Access Compliance Report

Public Rights-of-Way

(Curb Ramps)

Intersection ID: 50736	Main Street: JONES RIDGE DR	Cross Street: PROVIDENCE LN WEST	Location: E
ADA ID: 85A4D1EBBD70	Ramp Type: PerpDiag	Initial Pass/Fail: Fail	Overall Compliance: No
Severity Score: 12.5			
Codes/Mitigation Info/Possible Solution		Field Measurements/Component Compliance

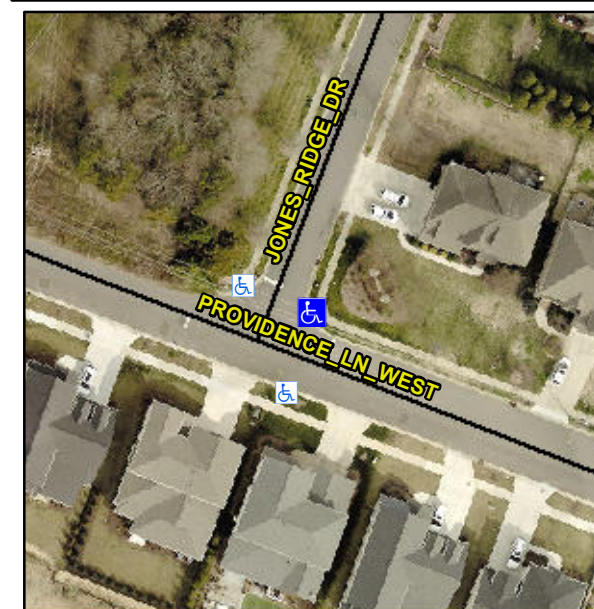
Not Found, R304.5.3

Compliance	Description	Data	Compliance	Description	Data
N/A	Ramp Length (in)	96.0	Yes	Ramp Slope (%)	5.7
Yes	Ramp Width (in)	48.0	No	Ramp XSlope (%)	5.9
N/A	Flare Type LT	N/A	N/A	Flare Type RT	N/A
N/A	Flare Slope LT (%)	N/A	N/A	Flare Slope RT (%)	N/A
N/A	Flare Traversable LT?	N/A	N/A	Flare Traversable RT?	N/A
N/A	Landing Length (in)	N/A	N/A	DWS Provided?	N/A
N/A	Landing Width (in)	N/A	N/A	DWS Contrast?	N/A
N/A	Landing Slope (%)	N/A	N/A	DWS Length (in)	N/A
N/A	Landing X Slope (%)	N/A	N/A	DWS Full Width?	N/A
N/A	Landing Curb? (Y/N)	N/A	N/A	DWS Offset (in)	N/A
N/A	Shared Landing?	N/A			
N/A	Gutter Ponding?	N/A	N/A	Gutter Slope (%)	N/A
N/A	Gutter Lip Ht (in)	N/A	N/A	Gutter X Slope (%)	N/A
N/A	Painted X Walk1?	No	N/A	Painted X Walk2?	No
	X Walk 1 Direction	To NW		X Walk 2 Direction	To SW
N/A	X Walk 1 Width (in)	N/A	N/A	X Walk 2 Width (in)	N/A
	X Walk 1 Slope (%)	4.2		X Walk 2 Slope (%)	2.1
	X Walk 1 X Slope (%)	5.0		X Walk 2 X Slope (%)	3.3

Remove & Replace Curb Ramp With Two New Directional Ramps or Equivalent.
